May 27, 2010

Mr. Jim Hedges, Chairman
Fremont County Solid Waste Disposal District
P.O. Box 1400
Lander, WY 82520

RE: Independent Hydrologic and Regulatory Review, Sand Draw Landfill, Fremont County, Wyoming

FIGURE 2

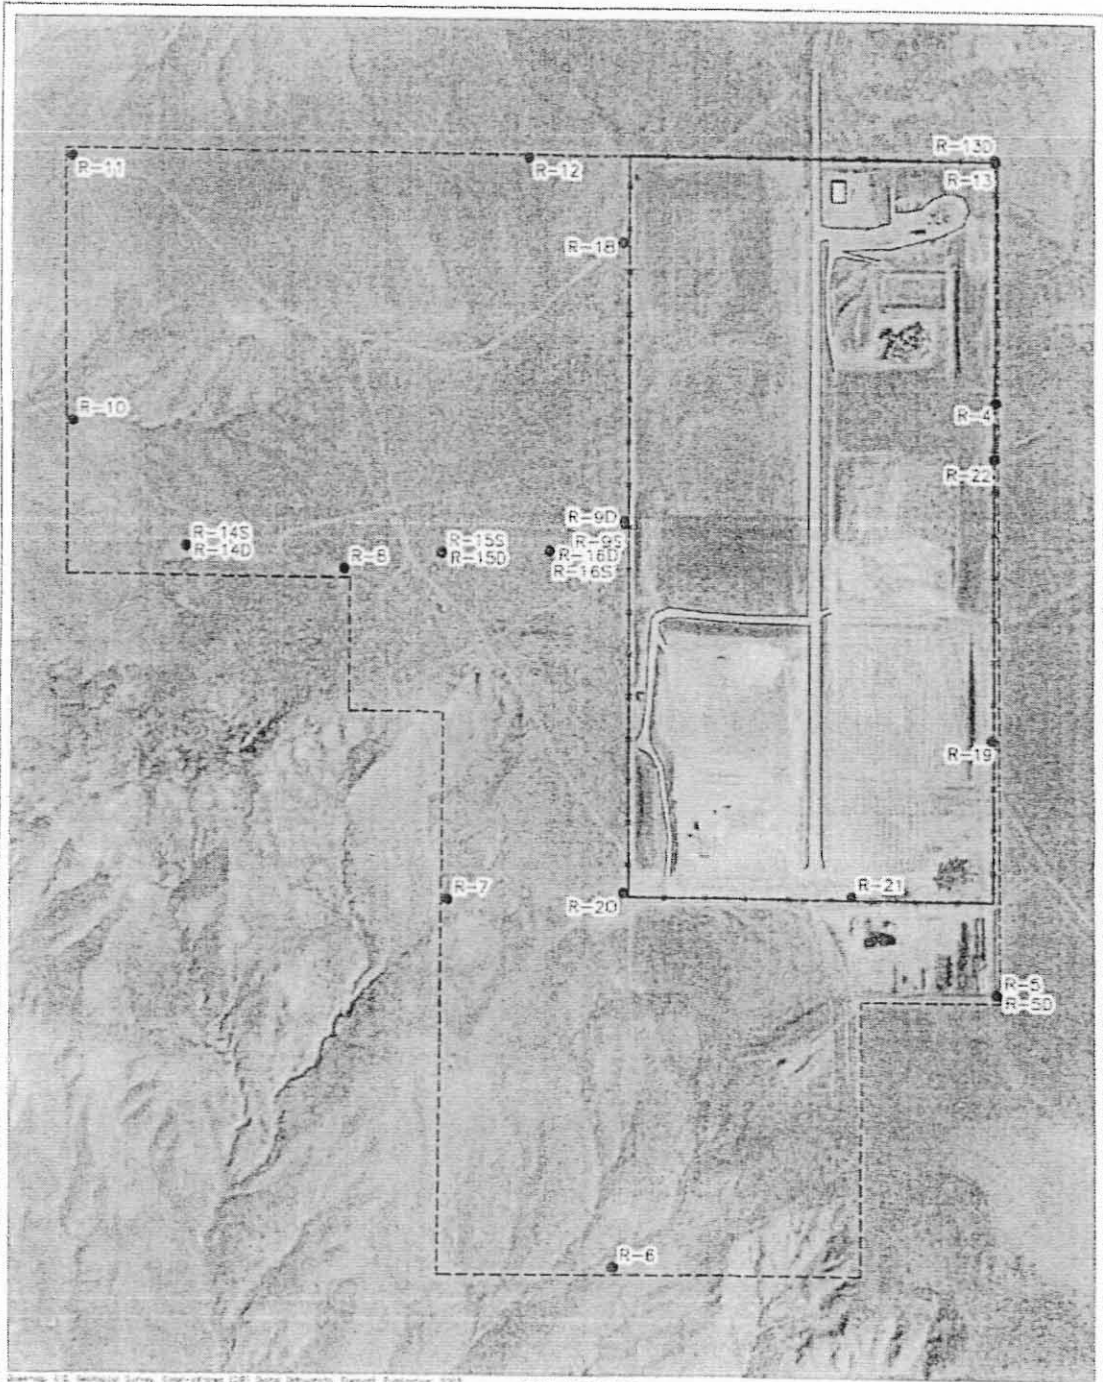
Additional groundwater monitoring wells on the proposed 133-acre landfill expansion area are also gauged on monthly basis, but samples are not collected for laboratory analysis (Figure 2). The wells located on the proposed landfill expansion area are not part of the groundwater monitoring program for the existing landfill operation (IME 2010a). Several of the wells on the proposed landfill expansion area (R-12, R-16S, and R16D) are within 150 meters (approximately 492 feet) of the permit boundary for the existing landfill operation.

FIGURE 9. R-9D, R-13D, R-18, R-20, R-21, AND R-22 PIPER PLOT
 (JANUARY 2010 EVENT)
 SAND DRAW LANDFILL, FREMONT COUNTY WY

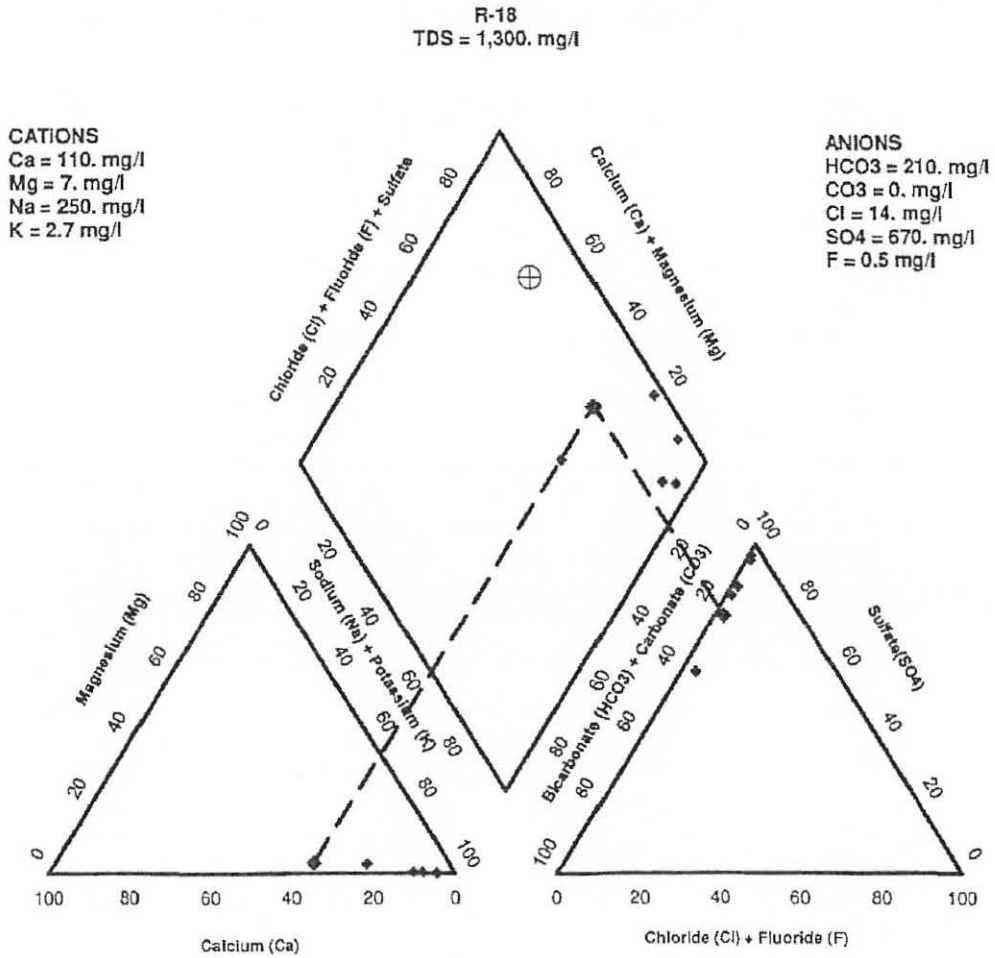
Figure 9, which contains plots for all the wells, indicates that the chemistry of wells R-18 (designated as a background well) and R-9D (designated as a down-gradient well, but may be hydraulically up-gradient of an existing portion of the active area) are similar and dominated by calcium cations and bicarbonate anions. The plots of the other down-gradient well data (R-13D, R-20, R-21, and R-22) suggest hydrochemical facies changes to lower concentrations of calcium cations and higher concentrations of sodium and potassium cations. The plots also suggest hydrochemical facies changes to lower concentrations of bicarbonate anions, and higher concentrations of chloride and fluoride anions. The distinct linearity of the noted hydrochemical facies changes may suggest a continuum across an interconnected groundwater system. If some degree of hydraulic connection exists between the up-gradient and down-gradient wells, the noted hydrochemical facies changes may be due to changes in the mineralogy of the water-bearing zones, or potential migration of landfill contaminants. In no hydraulic connection exists between the up-gradient and down-gradient wells, the noted hydrochemical facies change may be attributable to differences in the mineralogies of the water-bearing zones.
